REQUEST FOR INFORMATION

Project Name: KINDRED RESORT

Hardscapes Snowmelt Insulation

Kindred Resort @ Keystone
RFI-01245 Revision 0
response issued_04/26/2024

© OZ ARCHITECTURE
 ONE RIVER RUN
 ISSUED FOR:
 SITE PLAN AMENDMENT
 SHEET TITLE:
 CIVIL DETAILS
 SCALE: NTS
 SHEET NUMBER
C-501

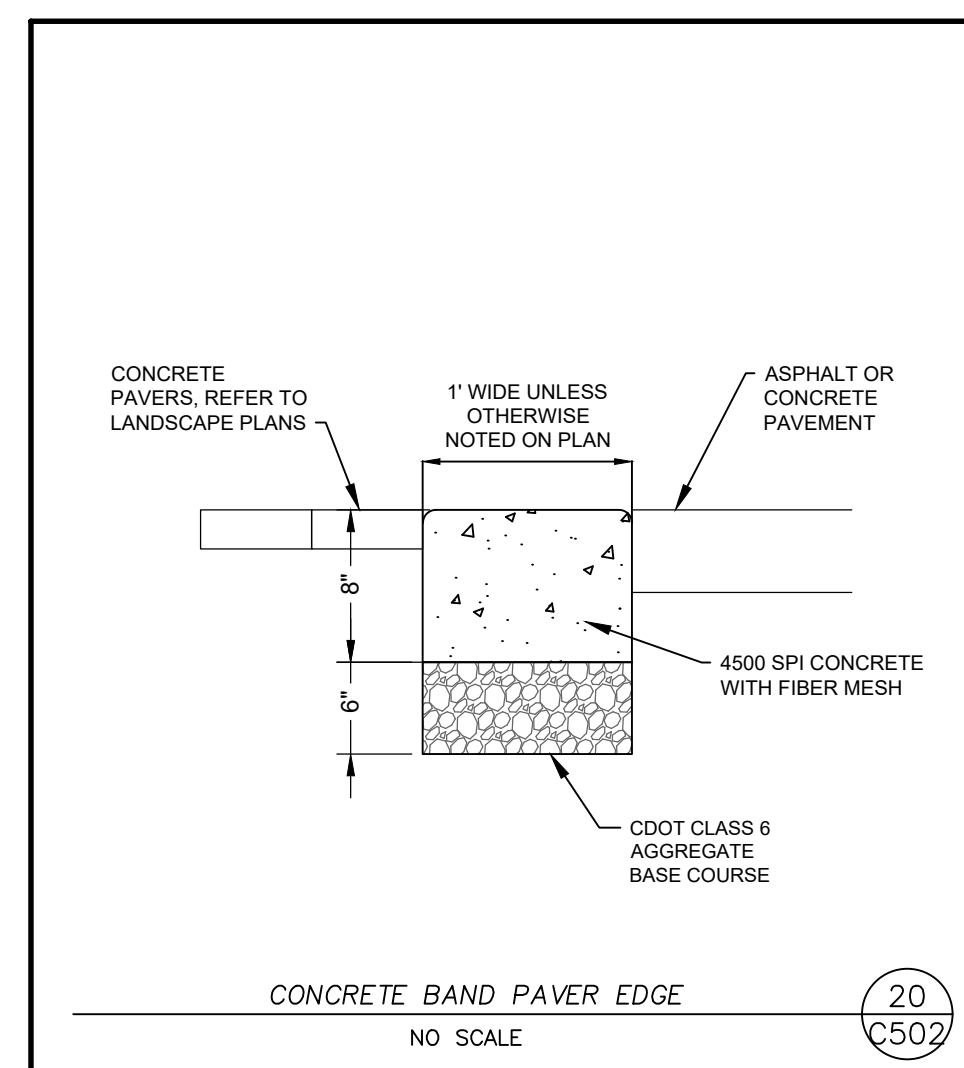
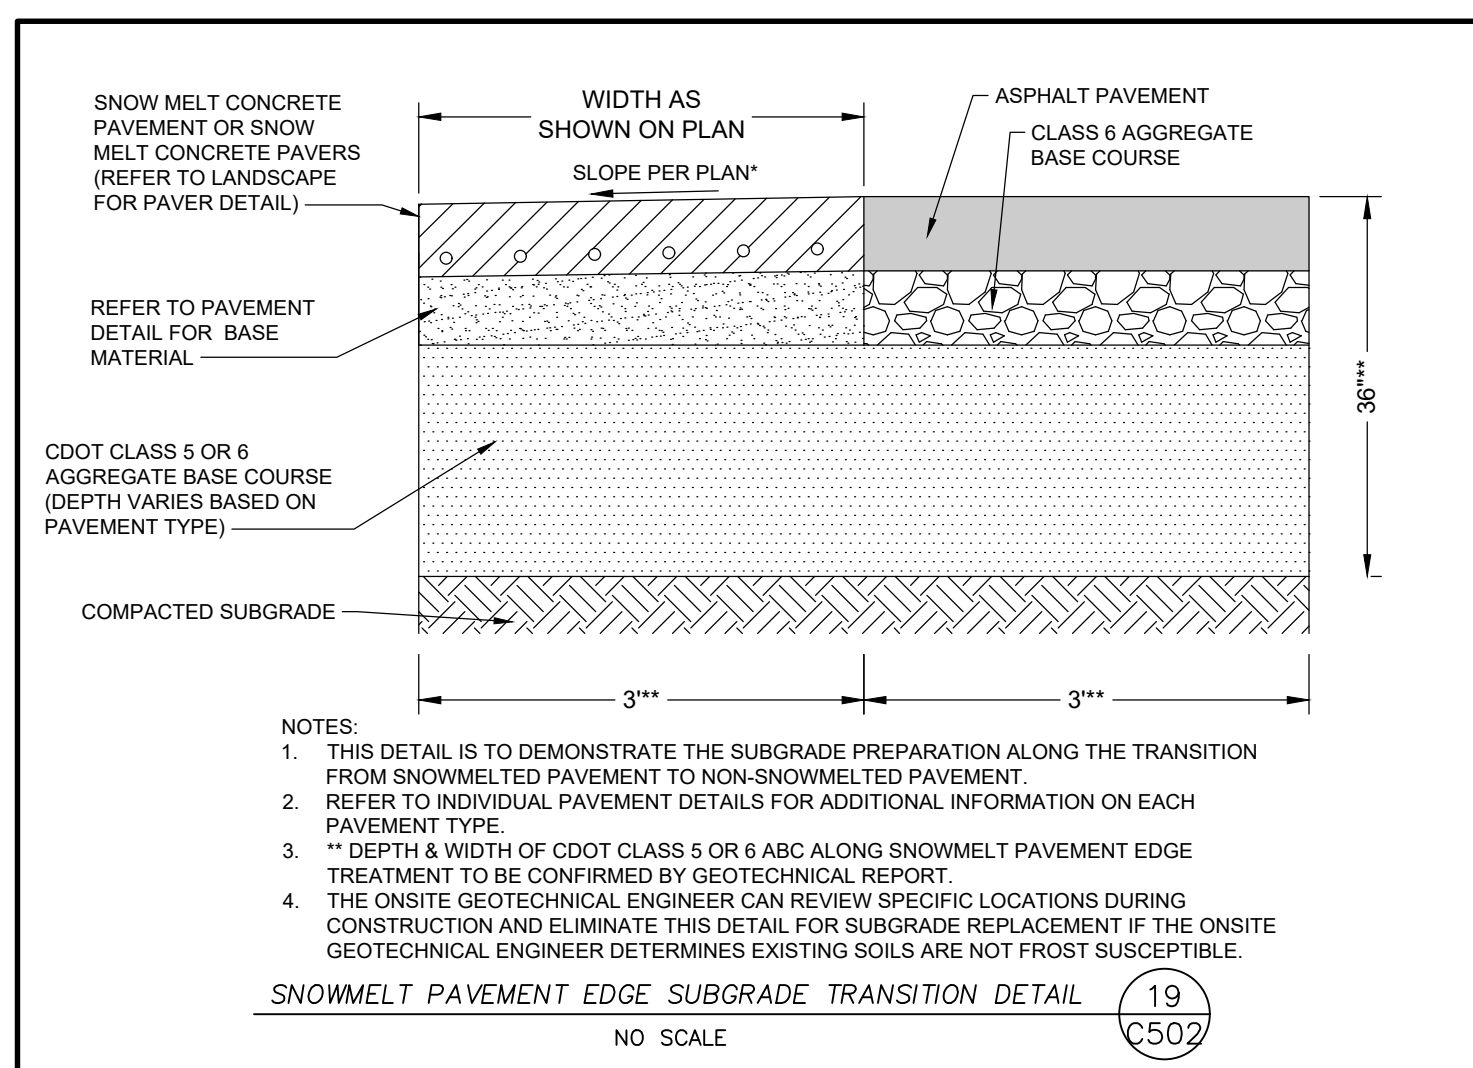
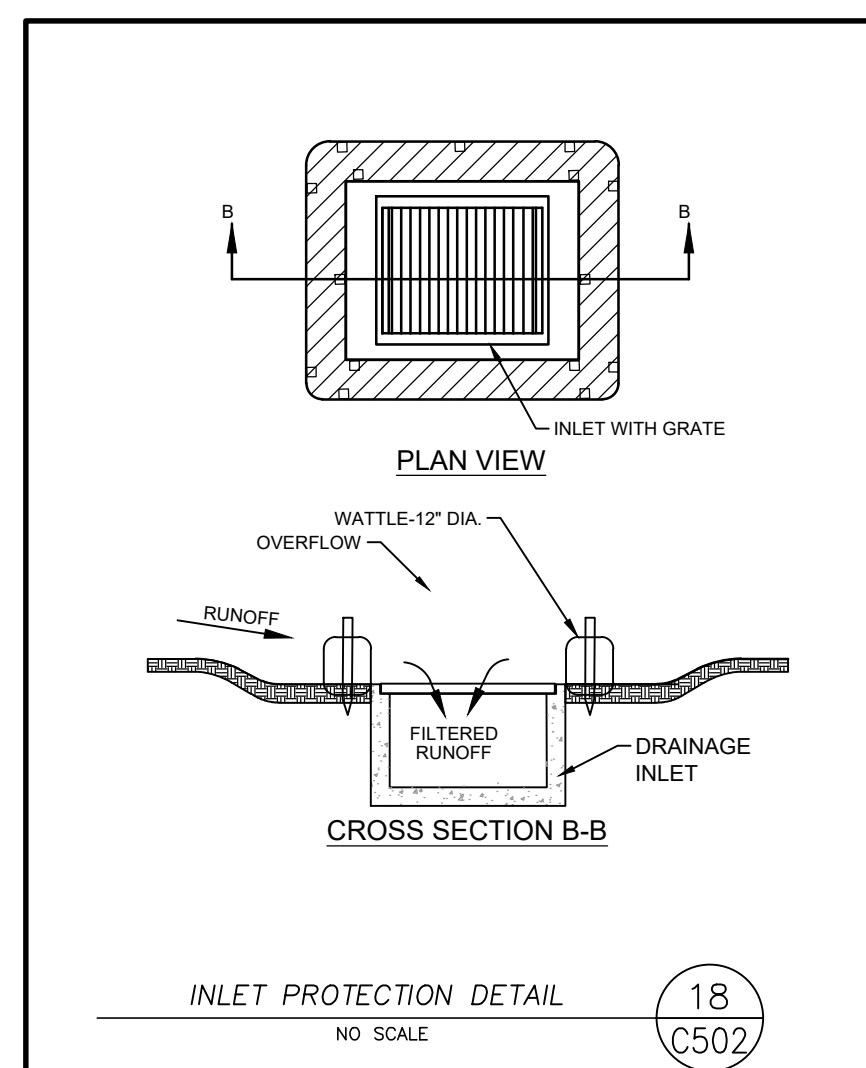
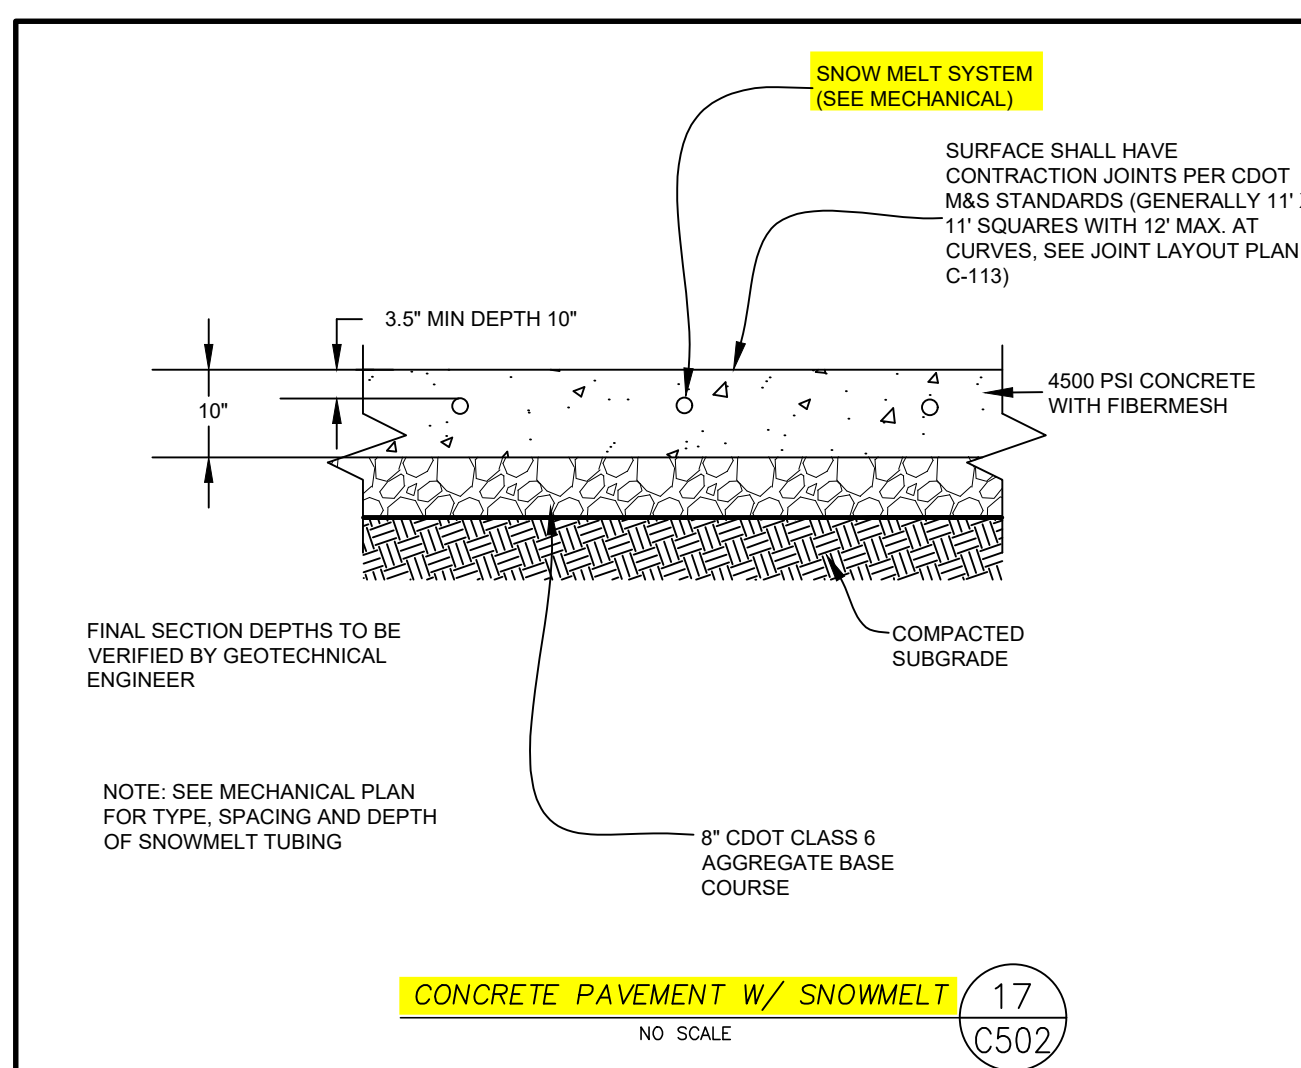
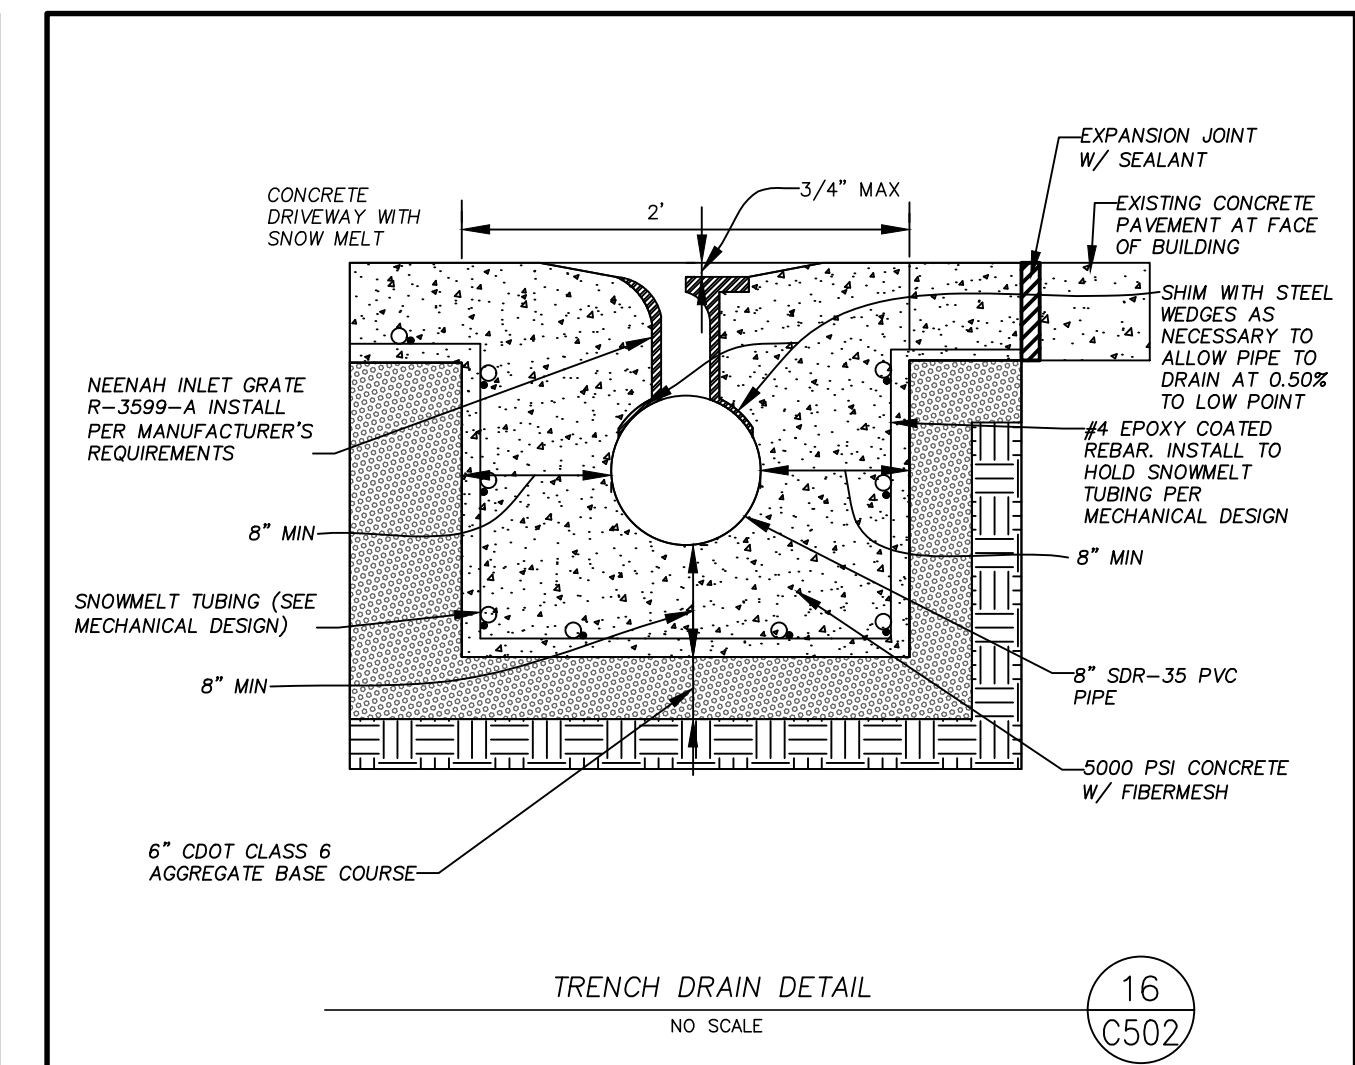
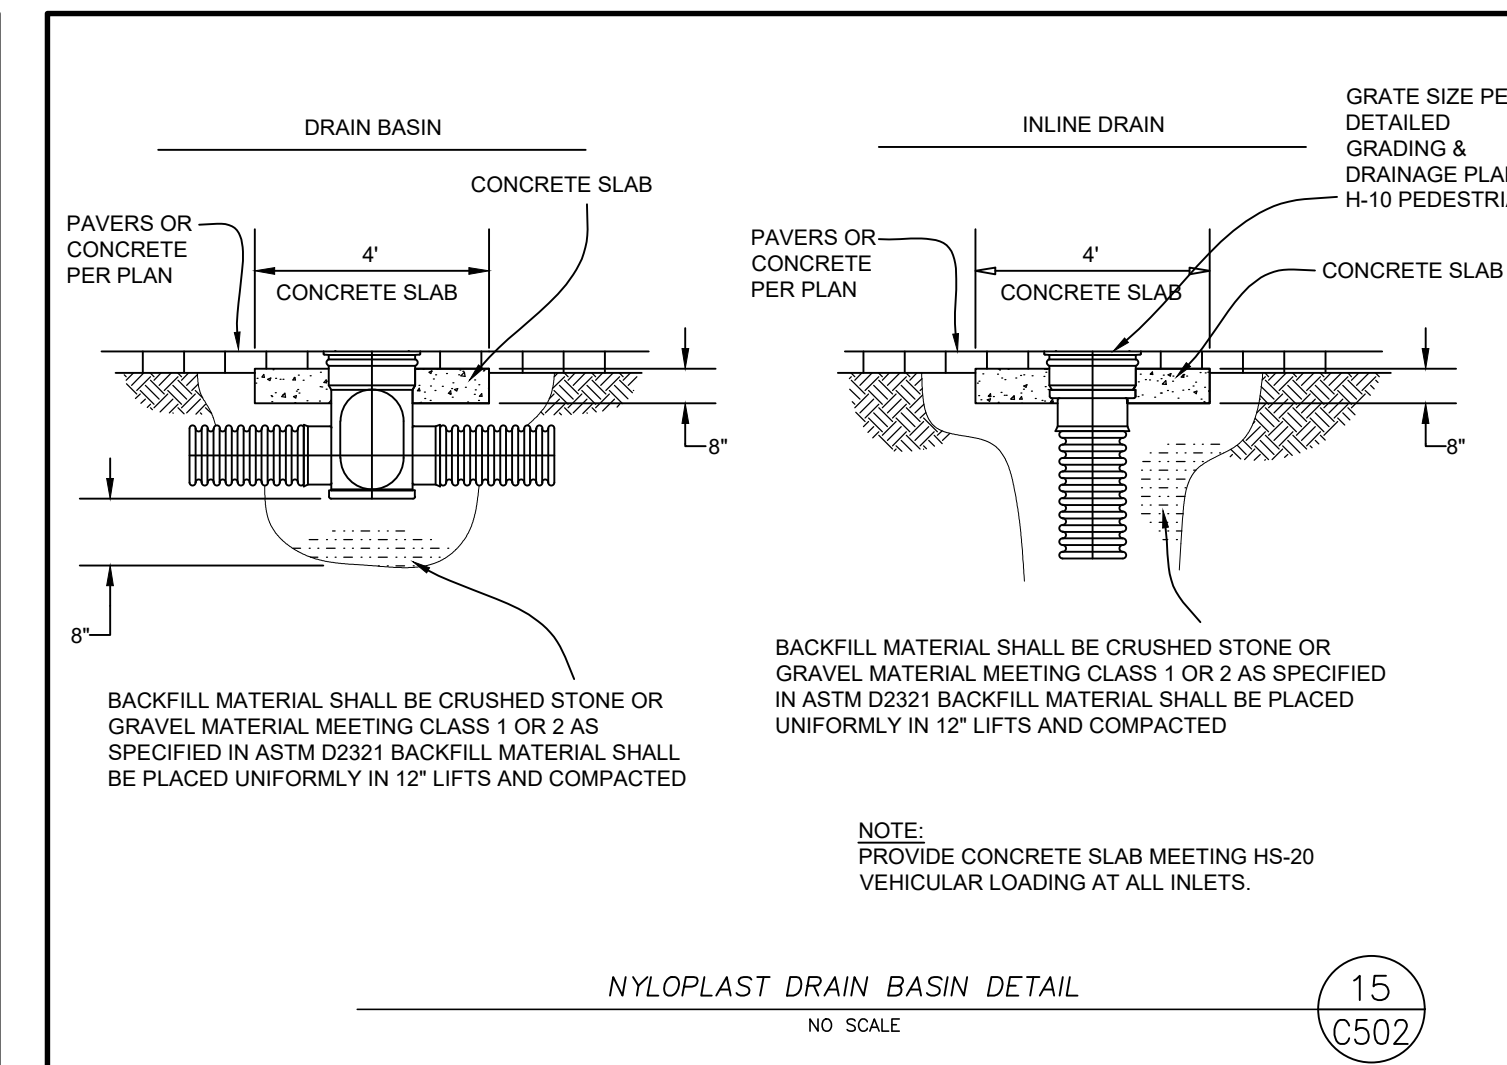
[Submitted: 4/22/2024 by Elliot Weiland, PCL Construction Services, Inc. Rev #0]
 Mechanical diagrams N & P for site snowmelt are shown on M-702 with underslab insulation required. Civil details on C-501 and C-502 do not typically show any foam under snowmelted pavement or curb and gutter.
 The snowmelt design was produced with 2" of rigid insulation.
 Insulation was assumed to be 25 PSI for pedestrian locations and 50 PSI for traffic rated locations per basis of GMP.
 1) Please confirm that 2" of rigid foam under all snowmelted concrete paving and snowmelted pavers is acceptable to Civil.
 2) Please confirm 25 PSI for pedestrian locations and 50 PSI for traffic-rated locations is acceptable.
 3) Please confirm that all top of grade at concrete paving and curb and gutter locations should be cut by an additional 2" to accommodate for the required foam.

- 1.The Civil plans include rigid insulation under the concrete sidewalks only, per detail 17/C-501. This was previously coordinated with the mechanical engineer during preparation of the construction documents. If the mechanical engineer has determined that the design of the snow melted pavement system should include rigid insulation under the concrete driveways and curbs subject to traffic loading, that insulation is required to be HI-100 (100 psi) rigid insulation. The Owner would need to review additional costs for any changes.

- 2.The rigid insulation under sidewalks indicated on detail 17/C-501 shall be HI-60 (60 psi) rigid insulation. This was previously reviewed and identified in submittal SUM-01727 by Tetra Tech on 4/11/24.

- 3.No changes to finish grade shall be allowed to accommodate additional rigid insulation. The subgrade would need to be lowered 2" to allow for the addition of new 2" rigid insulation.
